Subject: WPPSS NUCLEAR PROJECT NO. 2
RESPONSE TO QUESTIONS
SACRIFICIAL SHIELD WALL DESIGN

Reference: Letter, W.R. Butler to J.J. Stein, transmitting Request
for Additional Information dated July 8, 1974. (GI2-74-11)

SACRIFICIAL SHIELD WALL DESIGN SUPPLEMENTAL INFORMATION

WPPSS 74-2-R2-ATABLE OF CONTENTS

SECTION 2-2
(BASE DETAILS OF S.S.W. & R.P.V.)
SCALE 1"=1'-0"

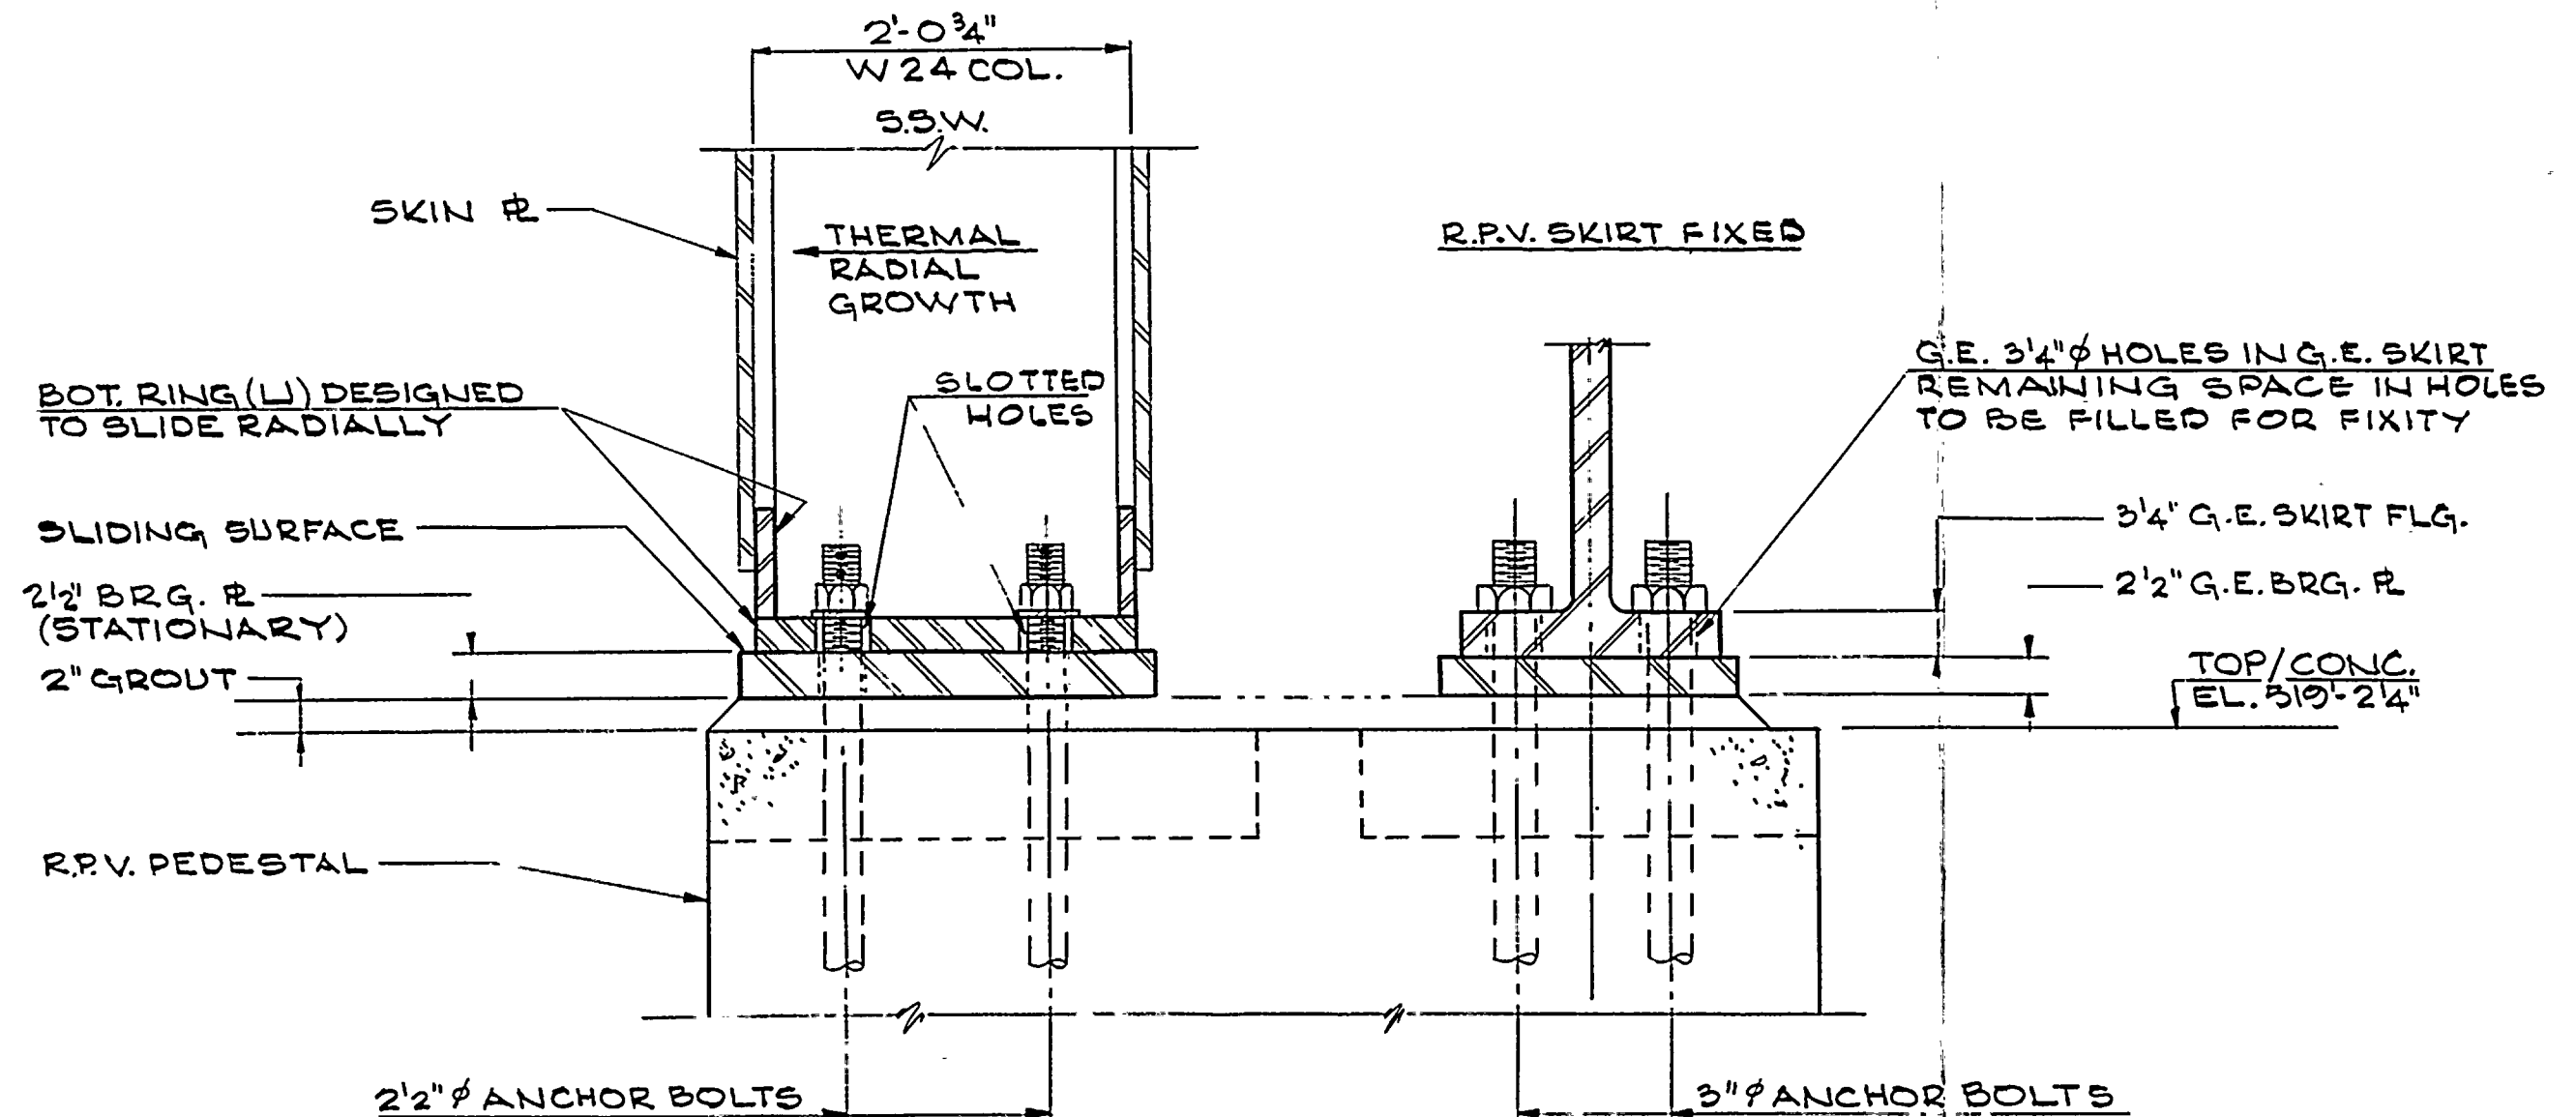
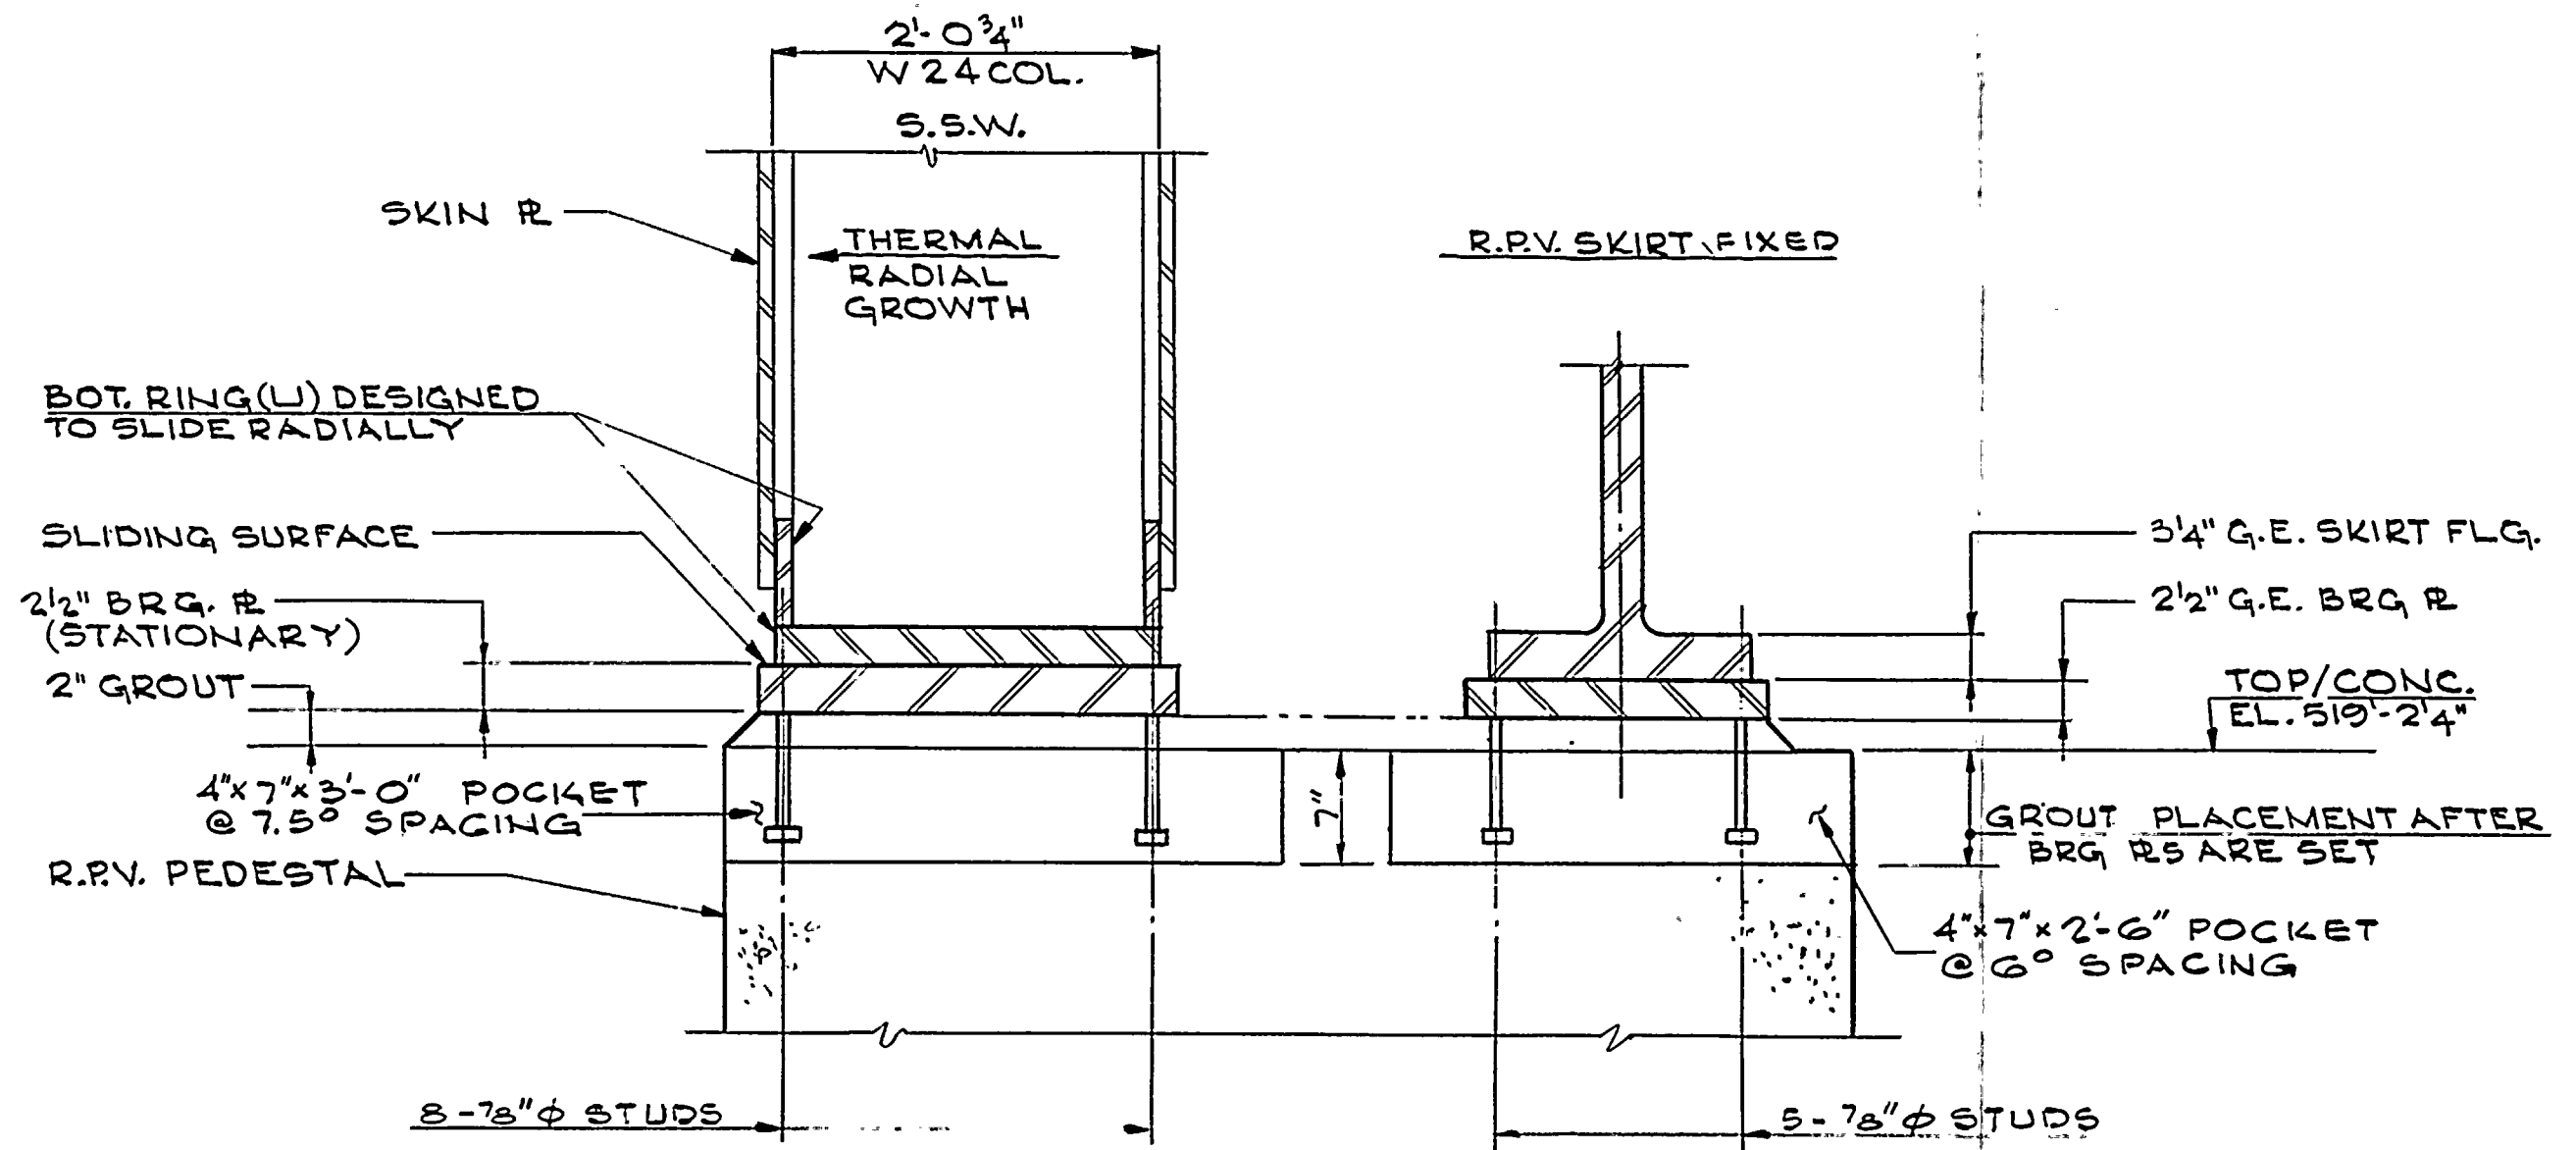
Furnish the applicable information listed in the Standard Format in sections cited above (3.5, 3.7, 3.8.3, 3.8.4, and 3.8.5).

Details of the base connections and upper pedestal are shown in Figures 25, 26, and 27. These figures comprise a plan at the top of the pedestal of base details of the SSW and RPV and sections illustrating such details.

- a. The SSW base is permitted to grow radially with respect to the bearing plate which, in turn, is anchored to the pedestal. Towards this end, the anchor bolt holes and the shear lug radial slots in the SSW base plate are provided with extra clearance in the radial direction.

- b. Shear lugs welded to the SSW bearing plate and passing through the radial slots in the SSW base plate will transmit shear in the tangential direction from the base plate to the bearing plate. Differential displacement in the radial direction between base plate and bearing plate, caused primarily by thermal growth, can take place practically unrestrained.

- c. Transmission of tangential shear from the bearing plate into the concrete pedestal will be by $7/8"$ x $8"$ headed stud shear connectors welded to the underside of the bearing plate. The connectors are arranged in rows of 8 each with a row spacing of 7.5 degrees circumferentially.

- d. The bearing plate will not be in position during construction of the upper portion of the pedestal. To accommodate the bearing plate studs, pockets will be provided in the top of the pedestal. These will be filled with grout at the time of installation of the bearing plate.

- e. Anchor bolts connect the SSW base plate to the concrete pedestal. These bolts provide the necessary resistance to uplift forces caused by postulated seismic and pipe rupture events. In addition, they serve as the required shear friction reinforcement for transmission of the tangential shear into the upper portion of the pedestal. Groups of four 2½ inch diameter anchor bolts are spaced at 15° circumferentially.
